INDIANA DEPARTMENT OF TRANSPORTATION

AGENDA

December 17, 2015 Standards Committee Meeting

RE: Agenda for the December 17, 2015 Standards Committee Meeting

EDITABLE IDM FIGURE: TEMPORARY SIGNAL TYPE DETERMINATION

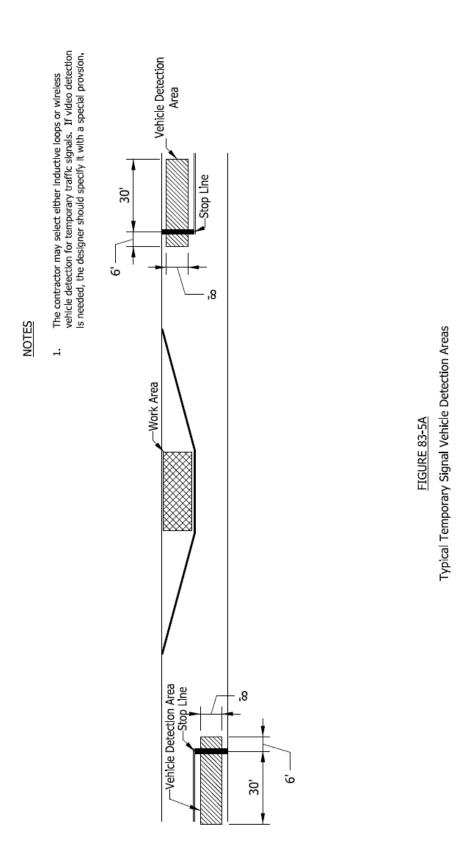
- 2. <u>Bridge</u>. If a lane is expected to be closed overnight, a temporary signal should be considered.
- Type of Temporary Signal. A temporary traffic signal may either be fixed or
 portable, the type selected should be detailed on the plans and the appropriate pay
 item included in the cost estimate.

If a temporary traffic signal is chosen as an element of the temporary traffic control plan the designer should consider whether it may be more cost effective to use a portable signal. Portable signals are mounted on trailers rather than wood poles and are generally rented by the contractor. When the need for a temporary traffic signal is expected to be less than six weeks, or the cost to bring electric service to the location is more than \$10,000, portable traffic signals will typically be less expensive. Portable signals require a flat area, approximately 8 ft by 8 ft in size, to accommodate the trailer.

In order to include the portable signal pay item into a contract the designer must obtain concurrence from the District Traffic Office that the portable type is the best option. This should be done by completing and submitting the "Temporary Traffic Signal Type Determination Form" to the District Traffic Office as early as possible in the plan development process but at least prior to Stage 1 plan submittals.
